TOWN OF BLUFFTON

STAFF REPORT Department of Growth Management

MEETING DATE:	June 22, 2016
PROJECT:	Cypress Ridge Commercial Building, RV and Boat Storage and Phase 7 Buffer Certificate of Appropriateness Highway Corridor Overlay
PROJECT MANAGER:	Erin Schumacher, AICP Senior Planner

1. **COFA-06-16-9716.** A Certificate of Appropriateness to permit the construction a commercial office of approximately 4,490 SF, RV and boat storage, and the Phase 7 Buffer along with the associated lighting and landscaping improvements. The property is located at the intersection of Highway 170 and Hulston Landing Road within the Cypress Ridge Development, zoned PUD, and lies within the Cyprus Ridge/Jones Estate PUD.

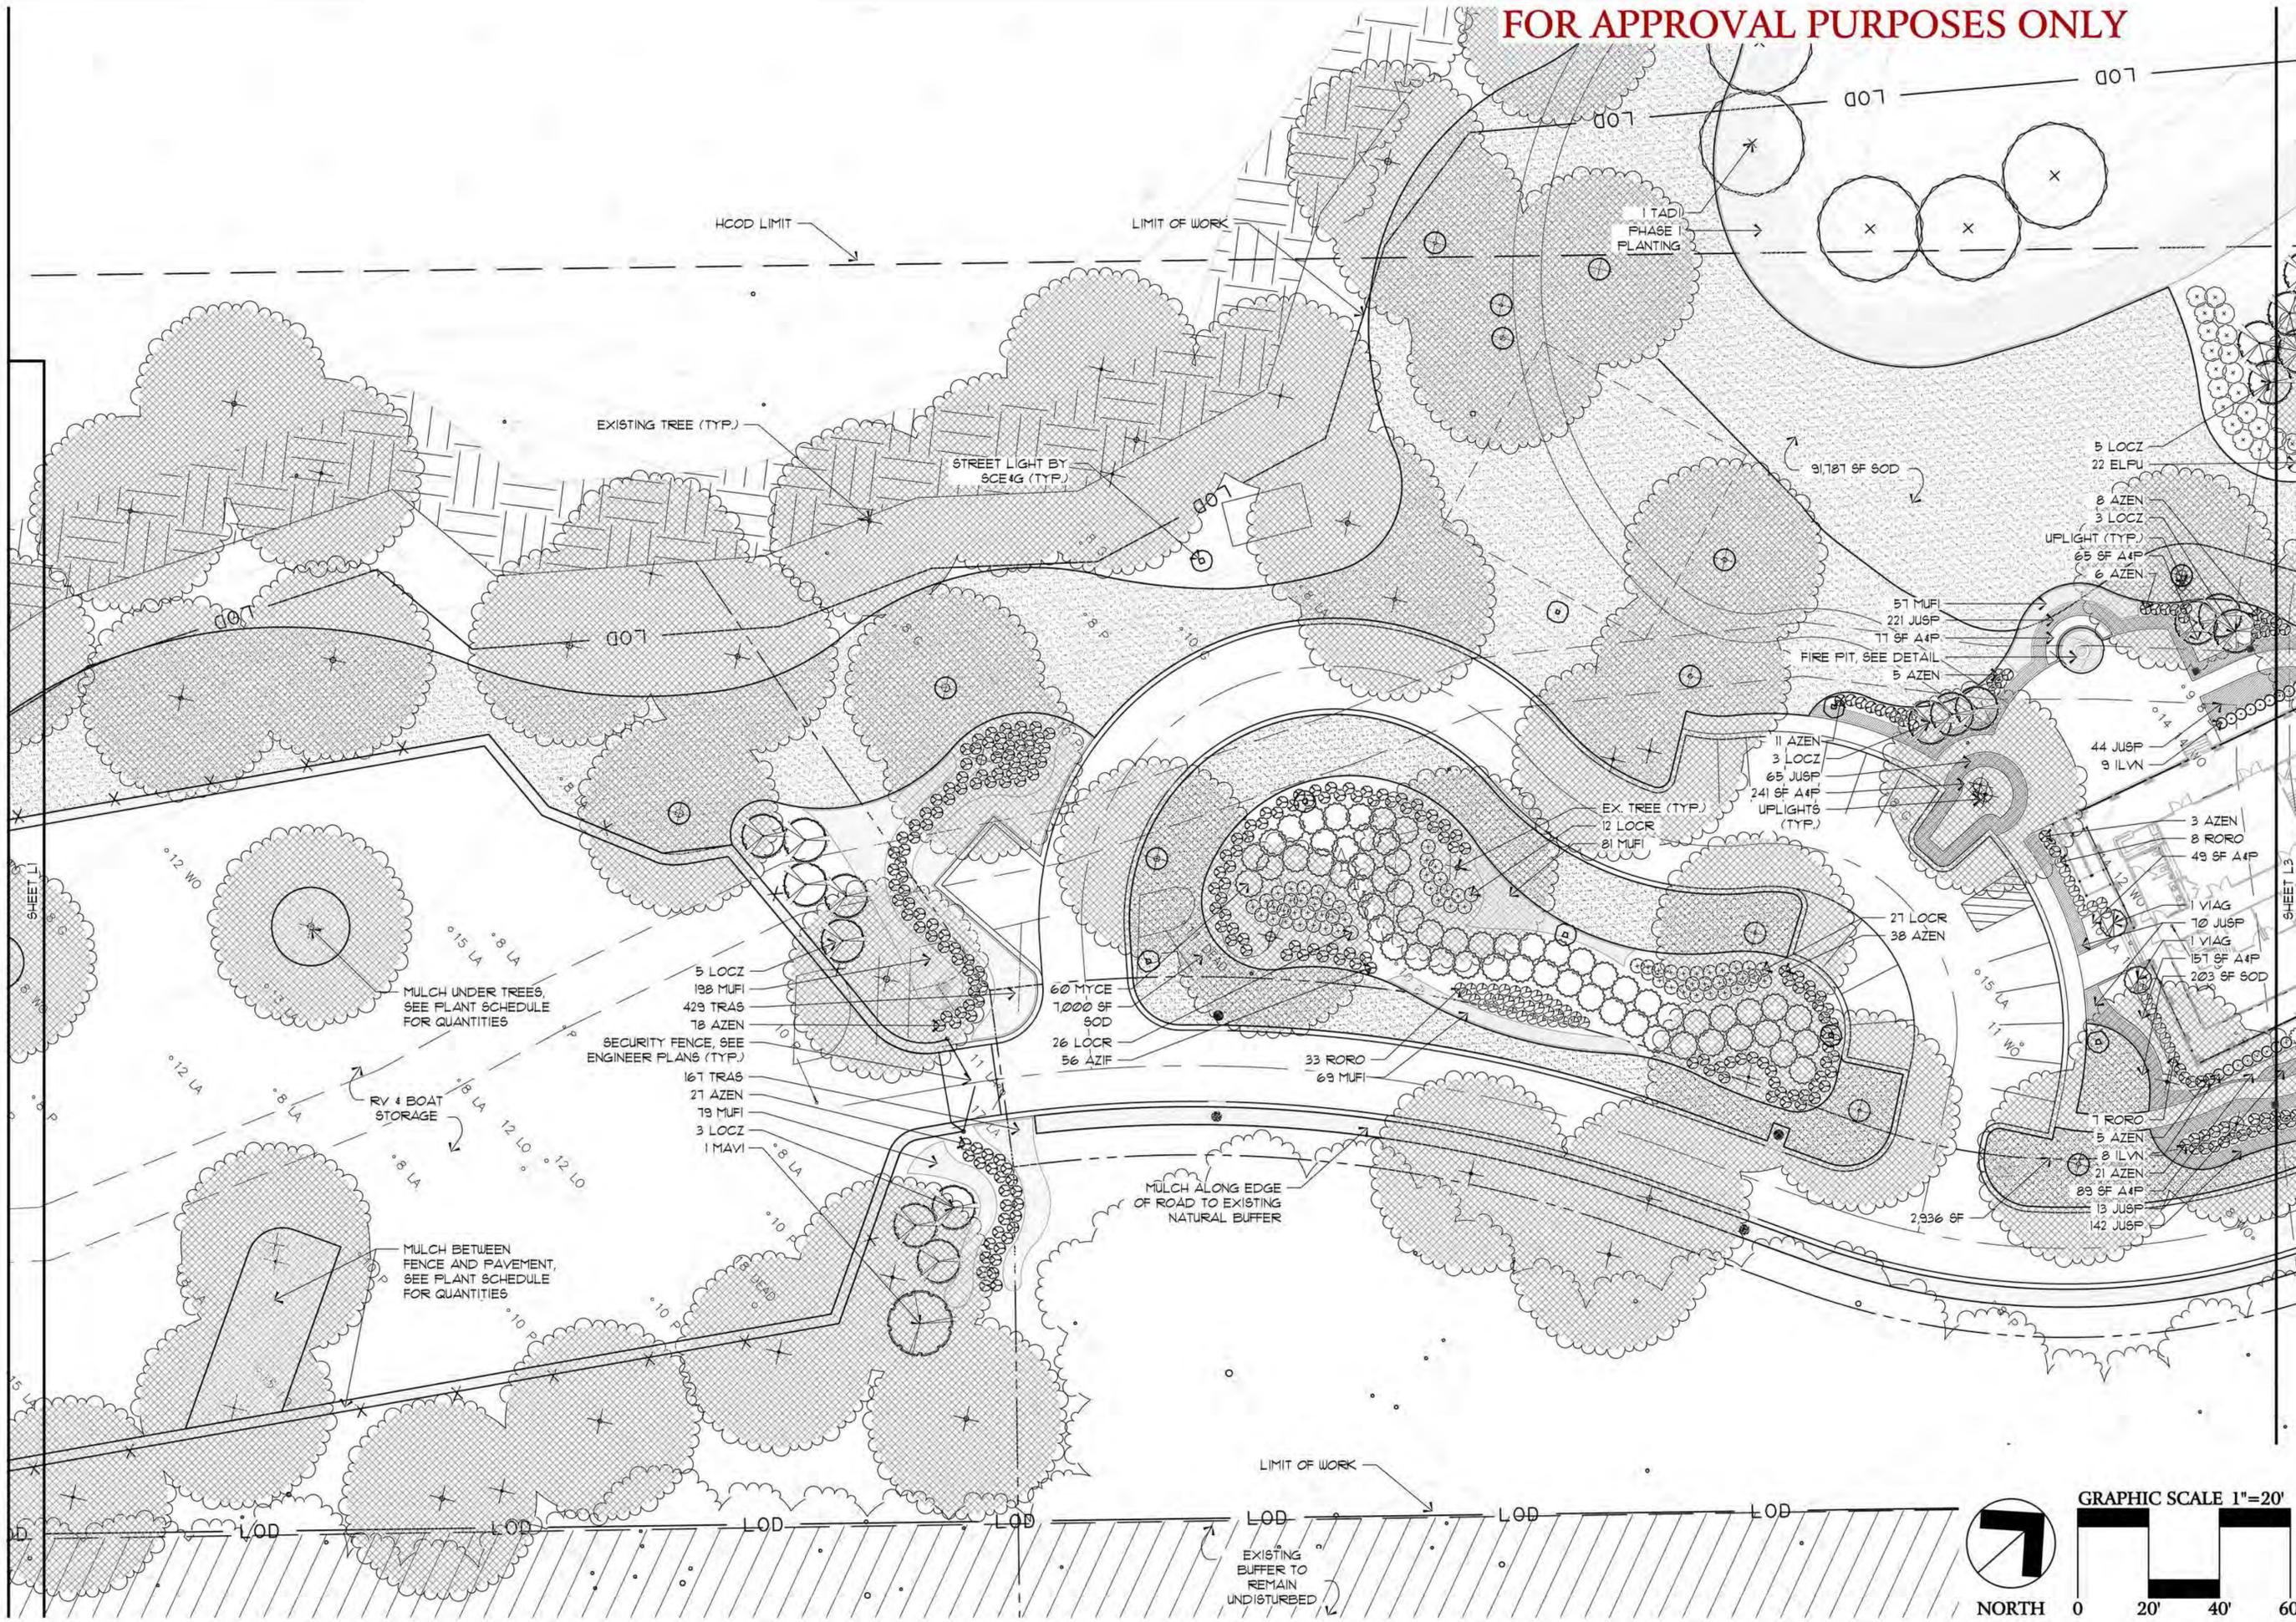
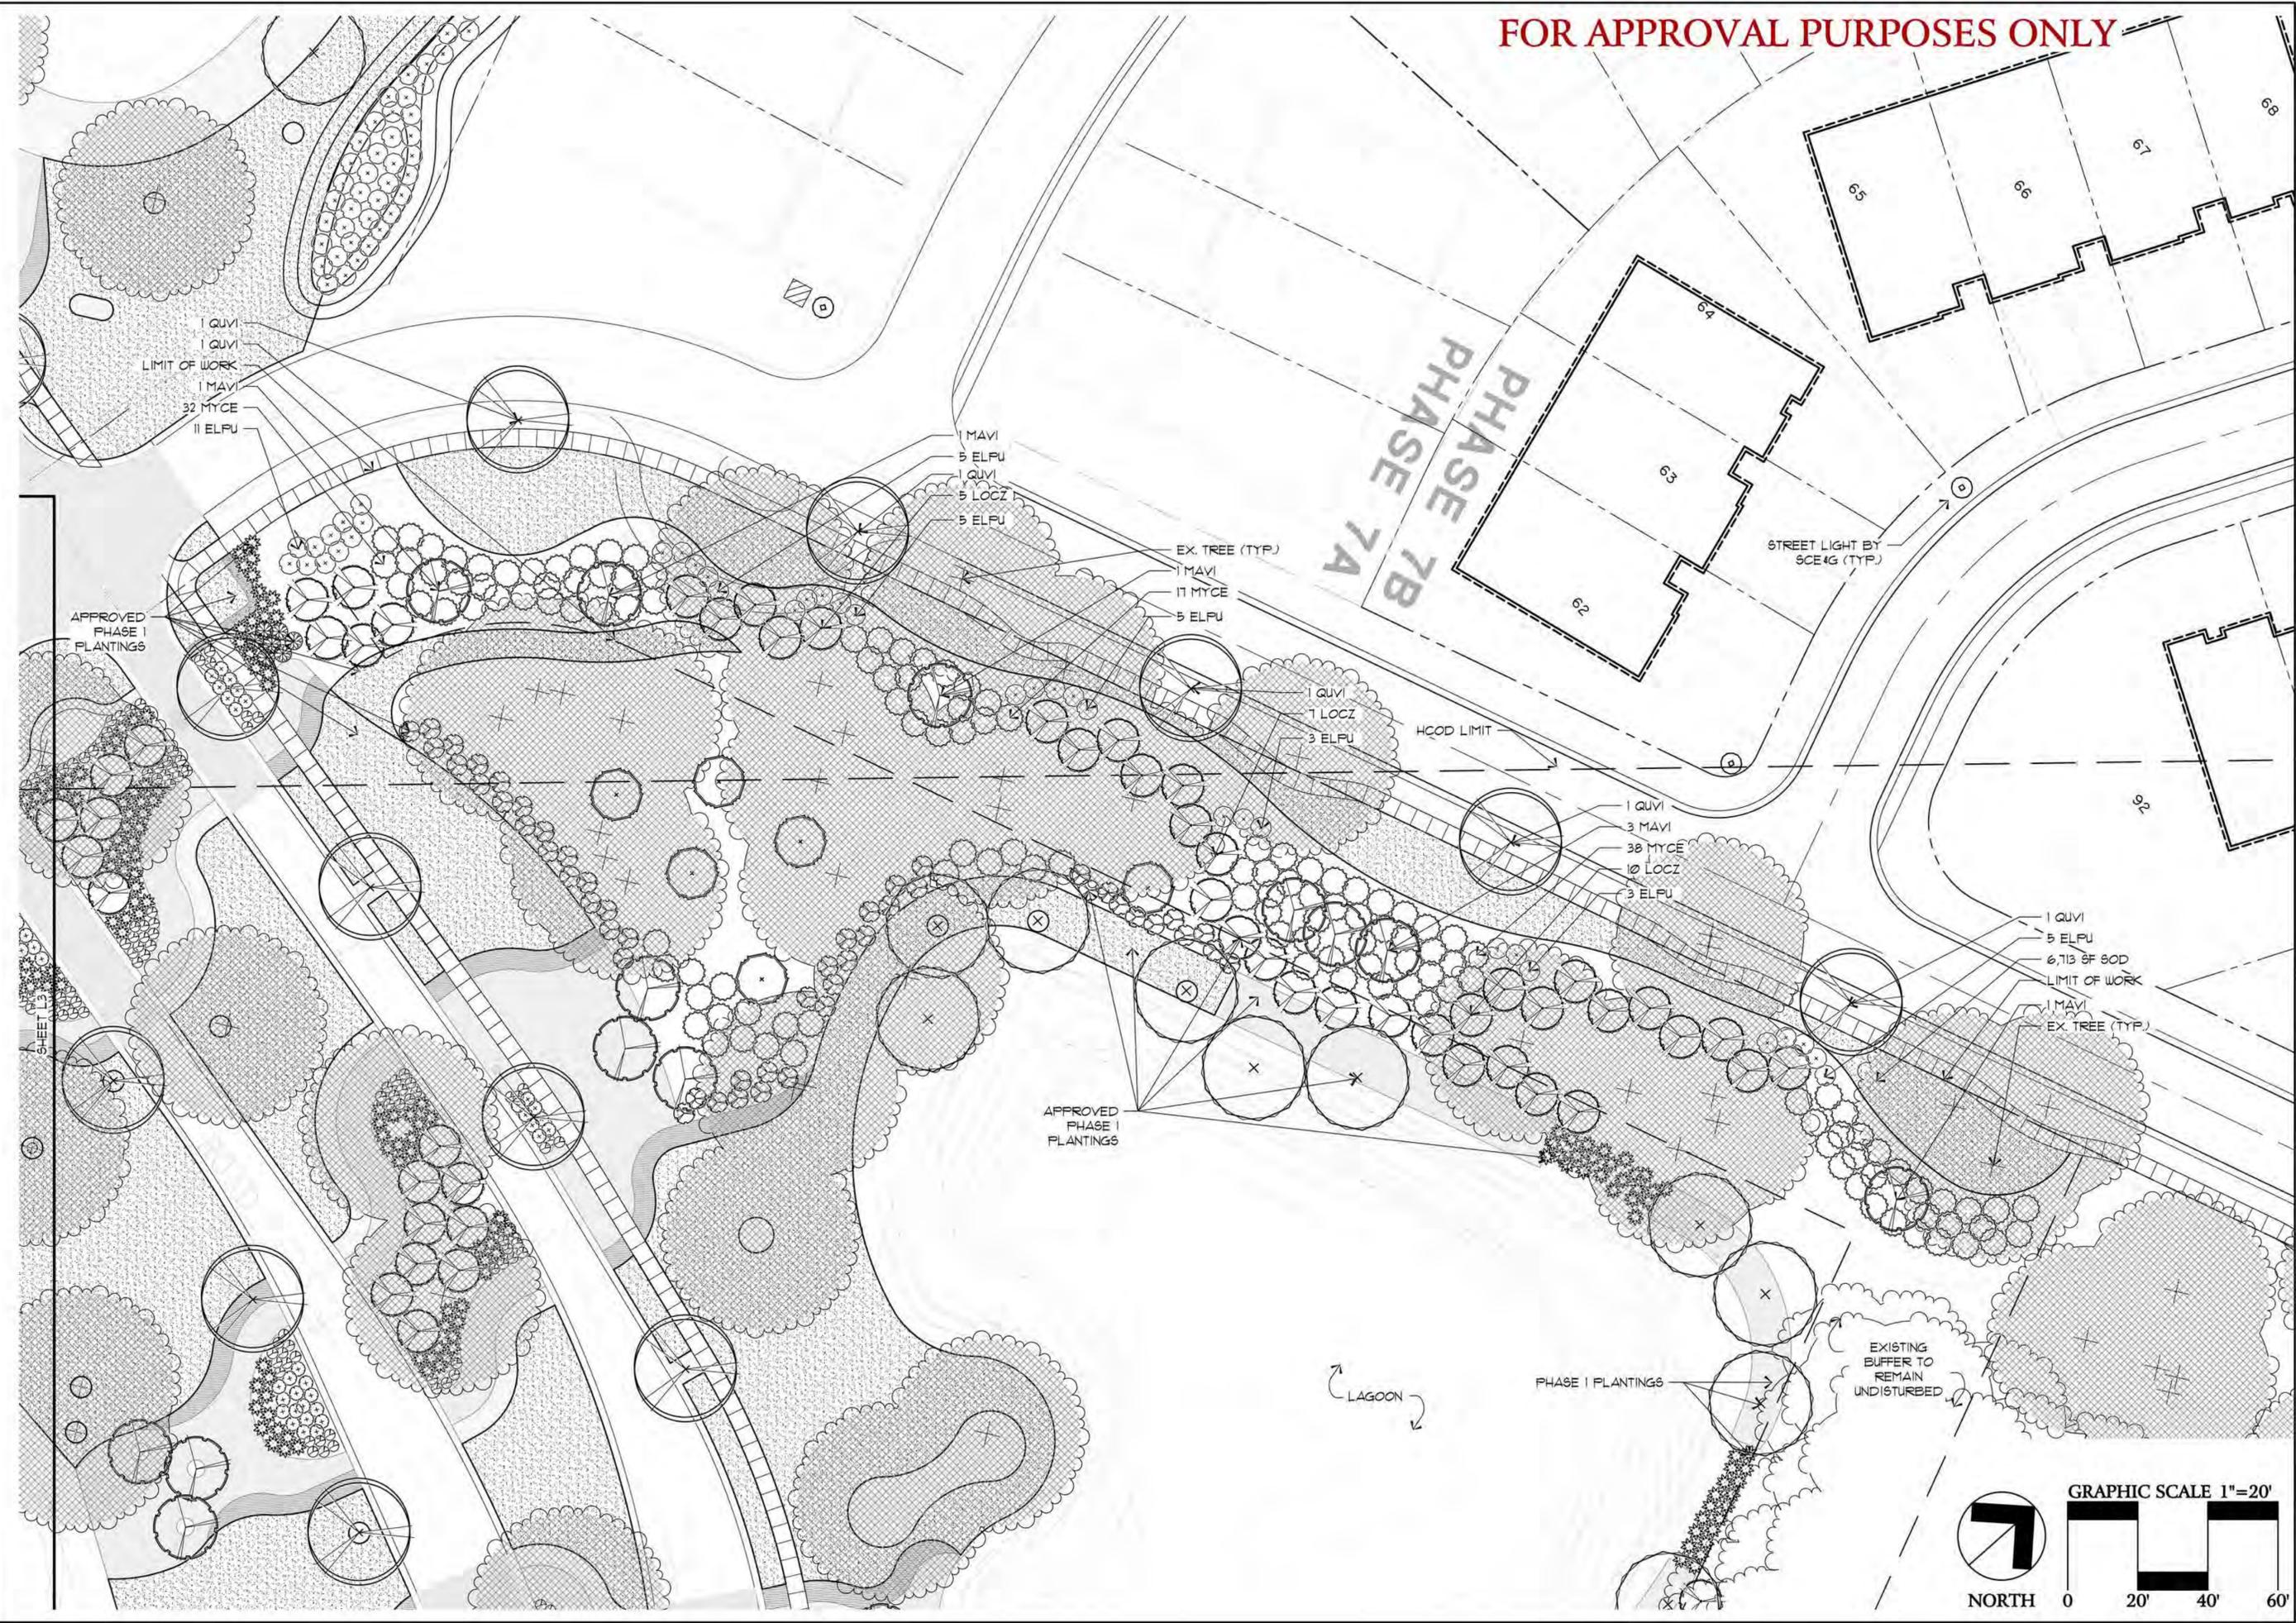
- 1) Finding – Highway Buffers. Section 4.24.2.1.A. of the ZDSO requires a 25' wide landscaped buffer parallel to the entire front of the property along the highway right-of-way and contain vegetative landscaping materials. While the applicant is proposing to preserve the existing trees within the 50' highway corridor buffer area, no additional plantings are proposed for the area along the highway right-of-way. The applicant shall comply with the requirement to provide a landscape buffer plan that will achieve a semi-continuous and semi-opaque vertical plane of tree canopy, understory trees and shrubbery coverage.

- 2) Finding – Landscaping. Section 5.24.2.1.C.1 of the ZDSO requires a minimum of six (6) broad-leaved overstory trees, seven (7) understory trees, and thirty (30) shrubs for every 100 linear feet for frontage on the highway. The applicant shall provide a planting plan that confirms compliance with this requirement. Existing vegetation may be used in the calculation in meeting this requirement and proposed tree removal for the entire site should be clearly noted.

- 3) Finding – Applications Manual. The Application for this project requires scaled architectural and site plans for review. There appears to be some discrepancies between the site plans in the architectural plan set and the site plans in the landscape/lighting plan set. In particular, the

configuration of the parking for the commercial building is inconsistent. These drawing sets must be revised for consistency.

- 1) *Finding – Other Requirements.* Section 4.24.4.C. of the ZDSO states that outside storage of other merchandise is permitted only at the rear of the property or behind completely opaque walls and screens. The proposed RV and boat storage area is located at the front of the lot and is not screened with opaque walls or screens but does not have a fence. Screening should be included along the southeastern edge of the storage lot to ensure that it is screened from view.

1. Landscape.
 - a. Per Section 4.24.2.1.A.of the ZDSO, provide the required plantings within the buffer area.
 - b. Per Section 5.24.2.1.C.1 of the ZDSO indicate the required plantings per 100 linear feet are provided and note proposed tree removal.
 - c. Per the Applications Manual, the architectural site plan and landscaping and lighting site plans must be revised for consistency.
2. Architecture

4. Other
- a. Per Section 4.24.4.C. of the ZDSO, screening should be included along the southeastern edge of the storage lot to ensure that it is screened from view.
